BP OIL CO.
RETAIL MARKETING
DESIGN AND ENGINEERING
 200 PUBLIC SQUARE
 CLEVELAND, OHIO 44114

PLOT PLAN
M.L. KING & 55TH
5425 M.L. KING BLVD.
OAKLAND, CALIFORNIA

DWG. NO.: 04-001-11127		REV.: _	
SCALE: 1"=10'-0"		MADE BY: GSJ	
DATE: 2/9.90		CHECKED BY: E.H.	
REVISIONS			
1) ADD UNDERGROUND TANKS, PRODUCT PIPING	DATE 5/17/80	DWN CF	CKD SI

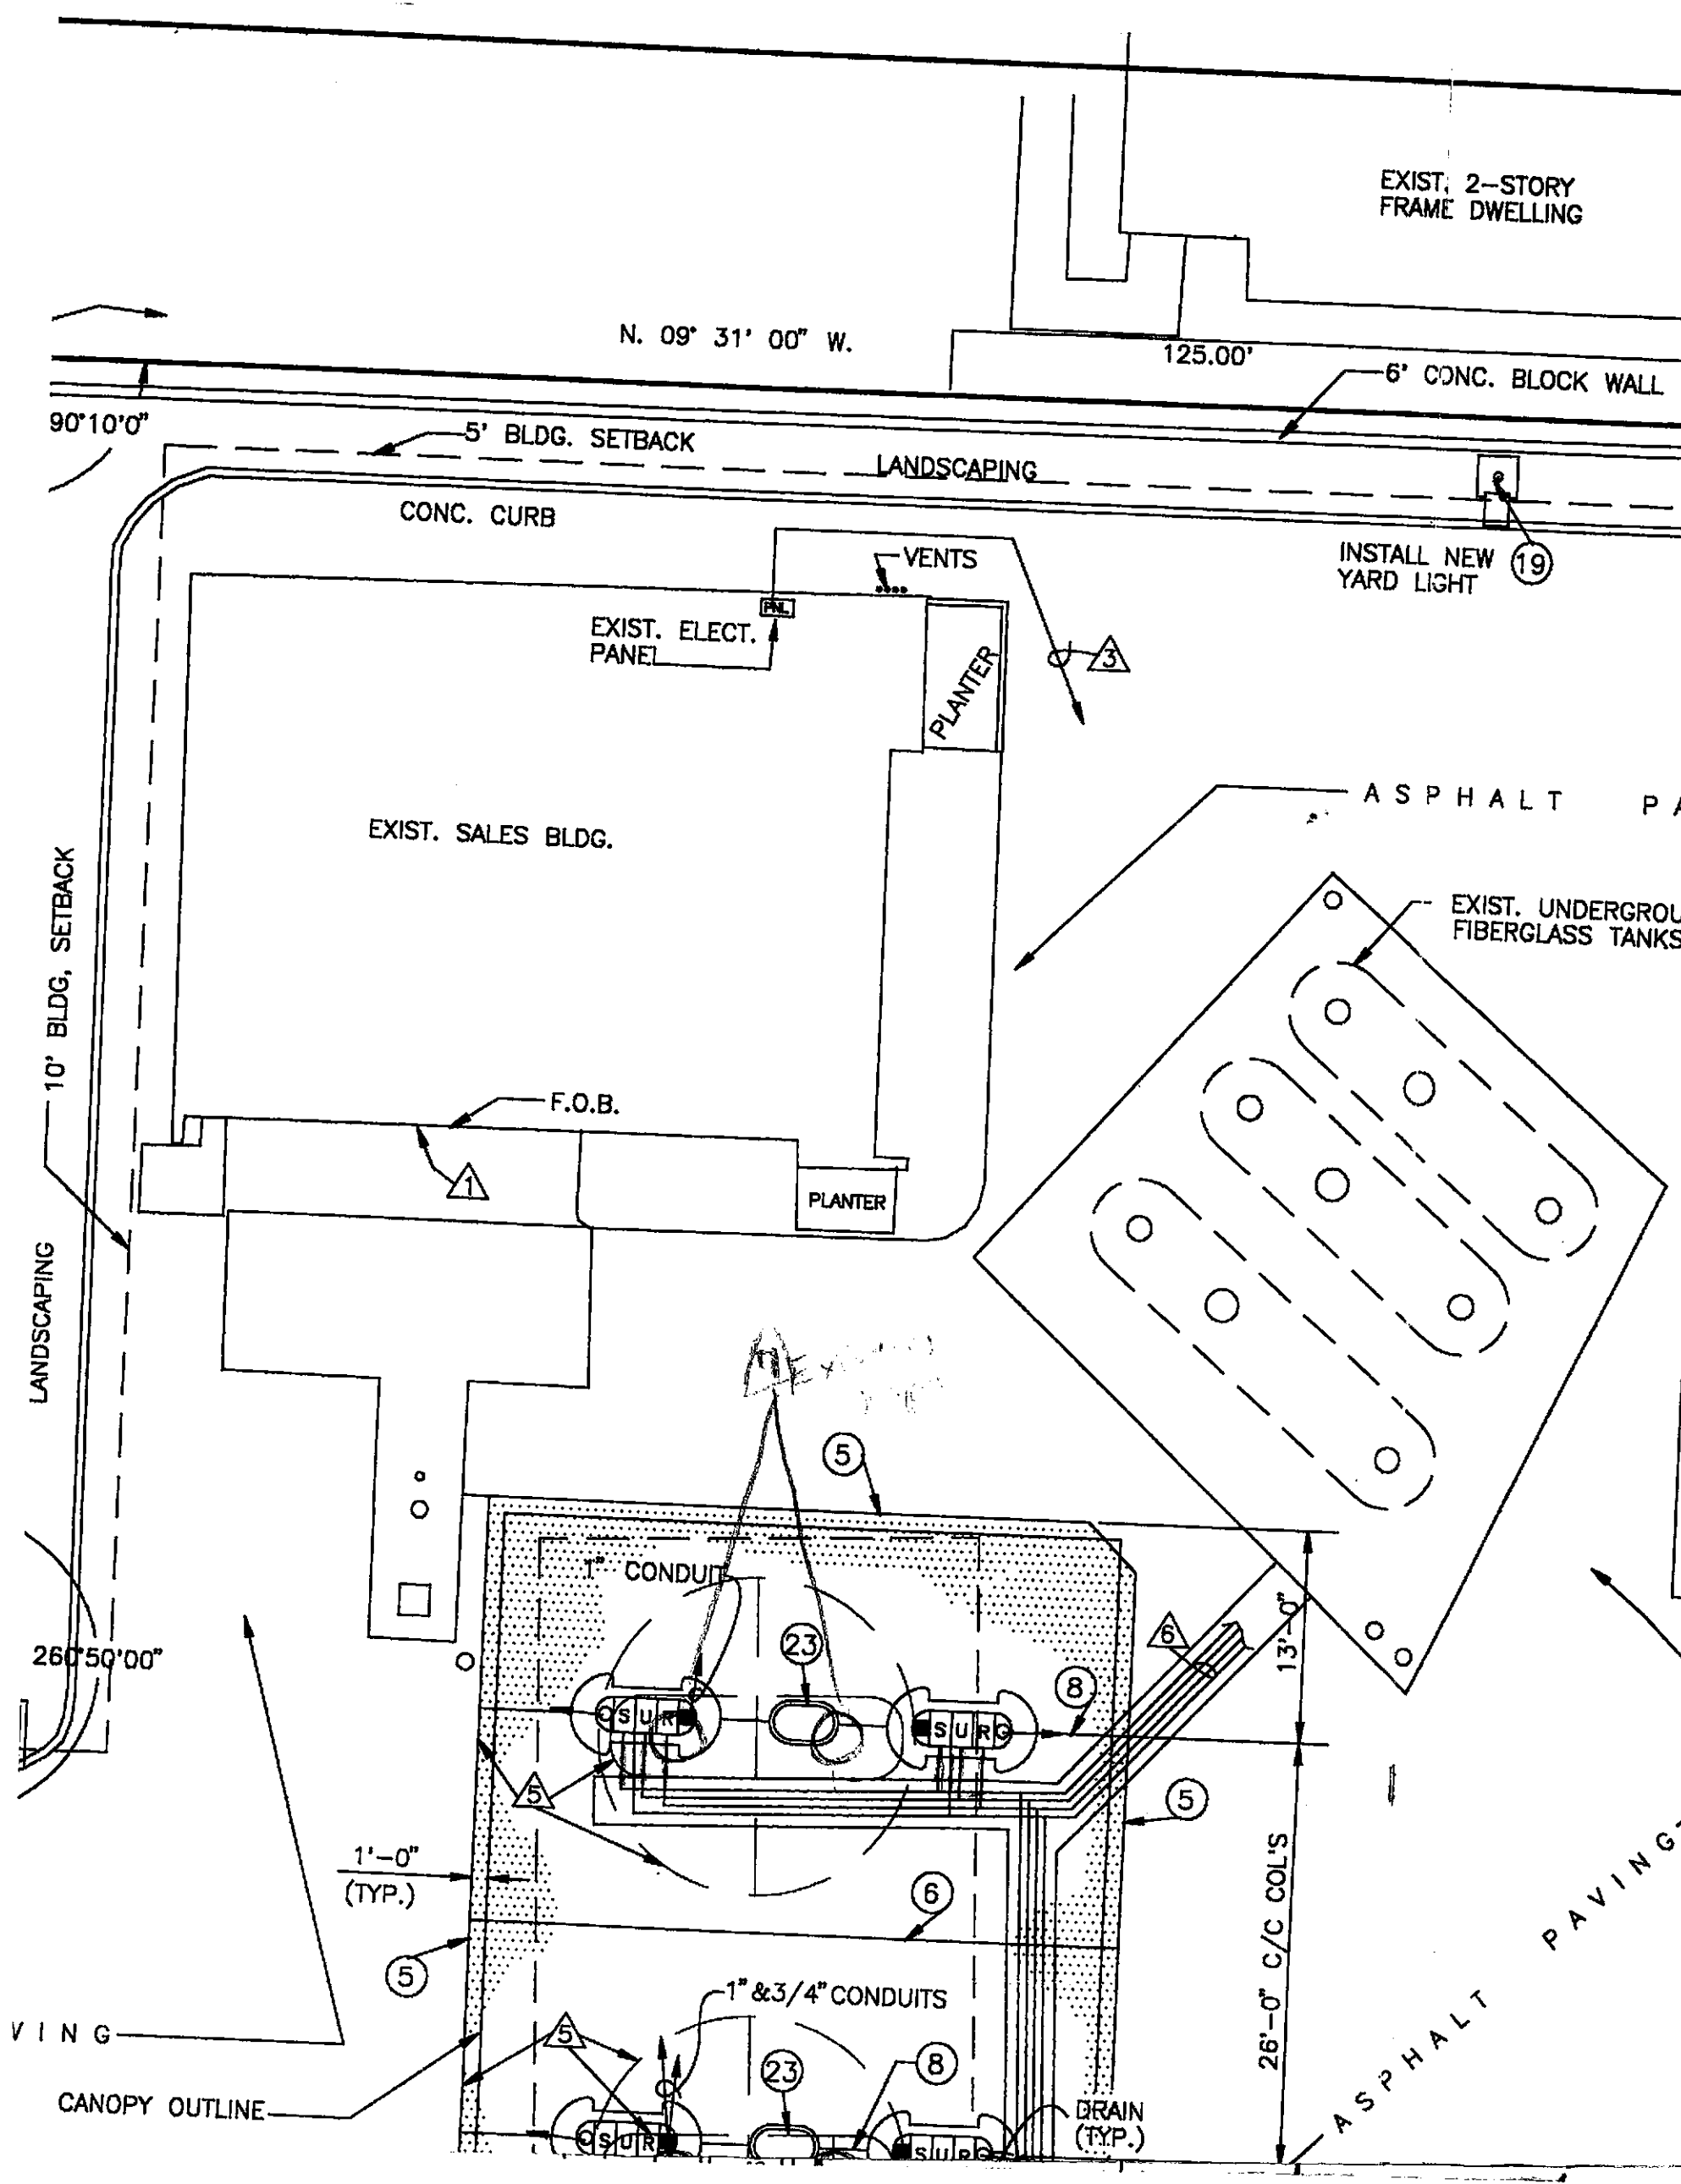
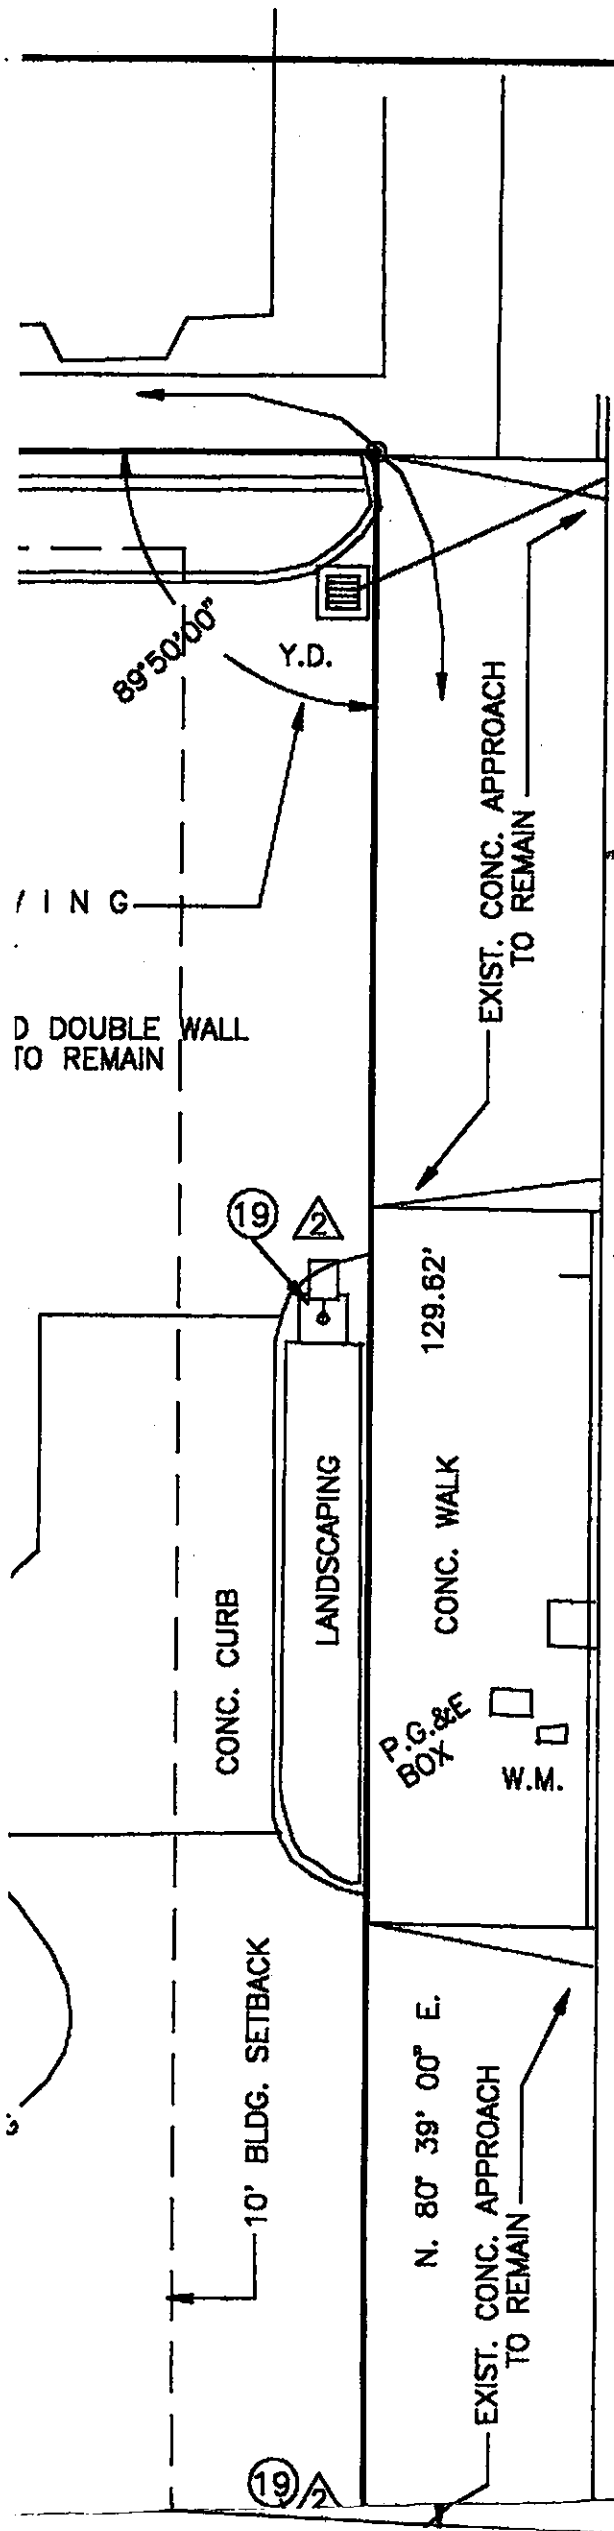
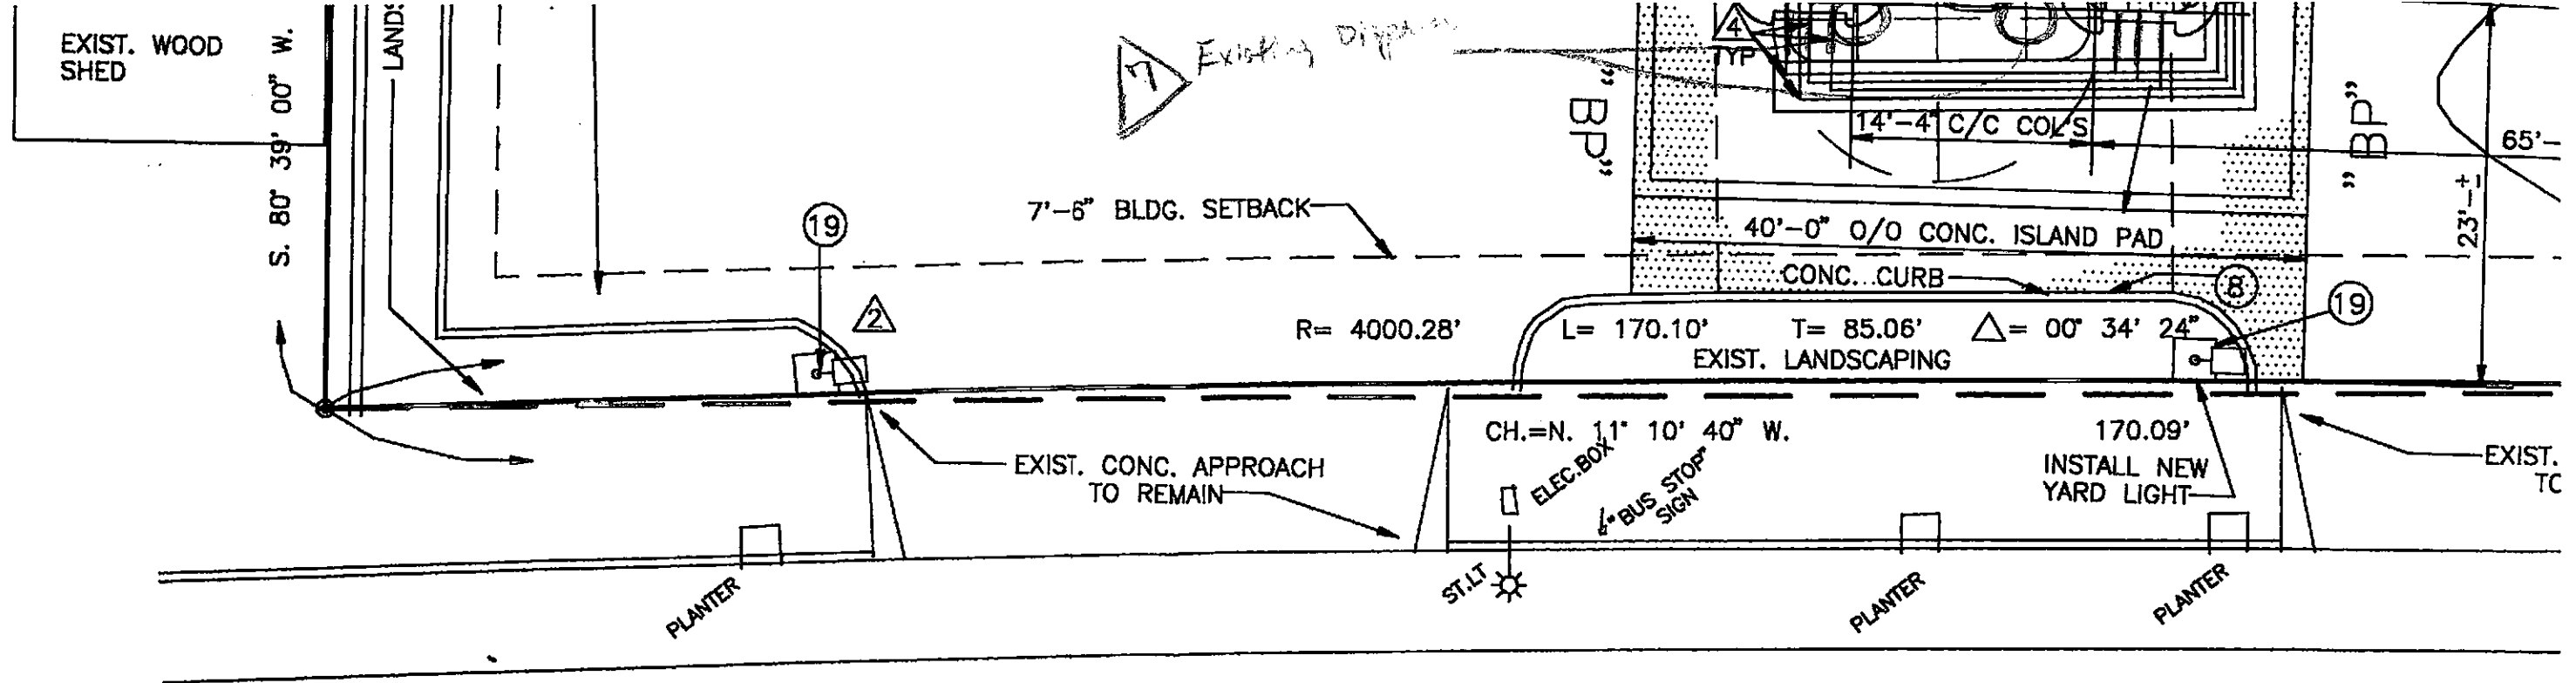
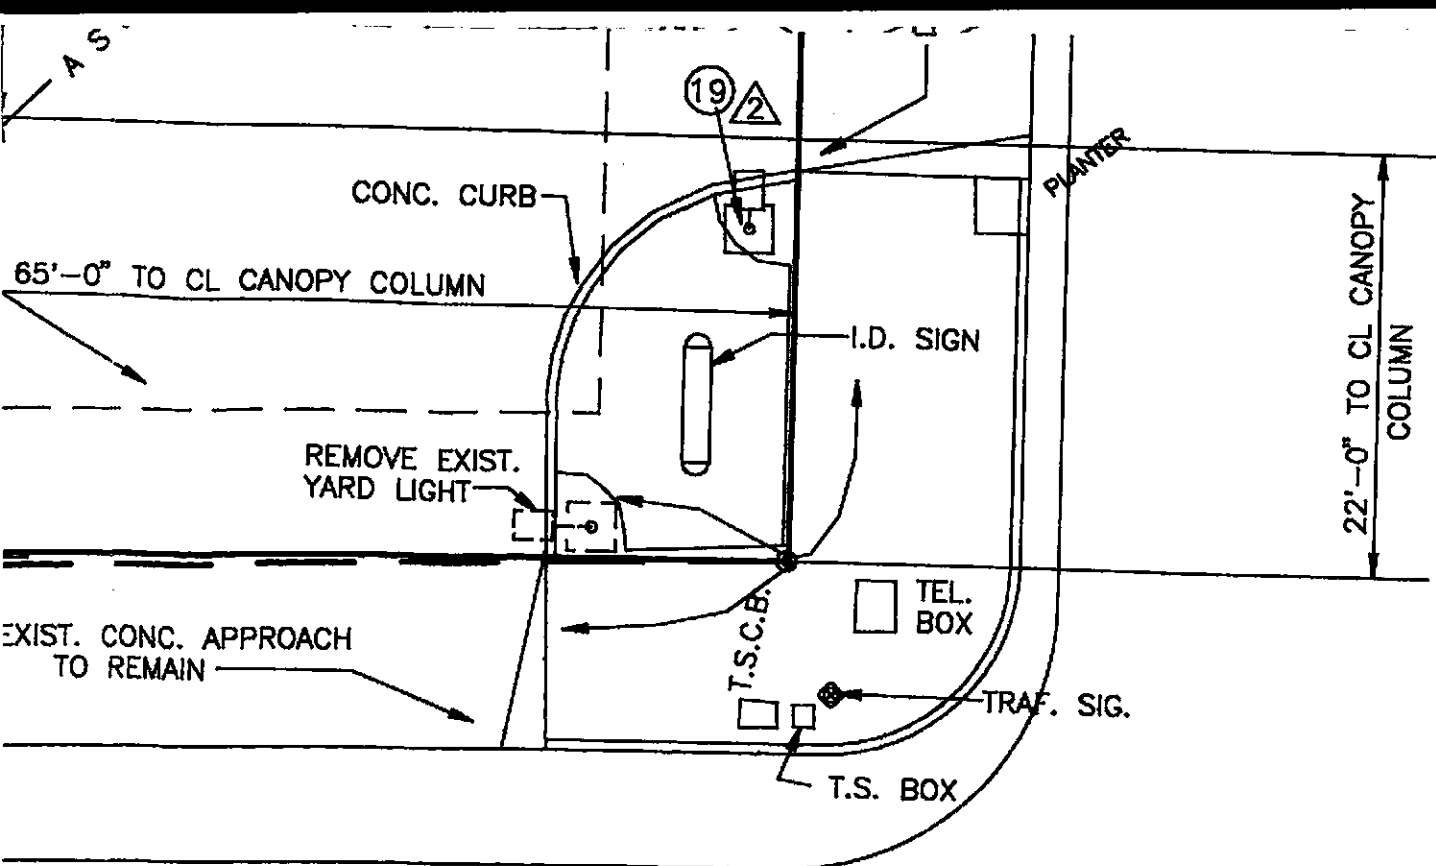
A system precision should be done.

As system precision test must be done.
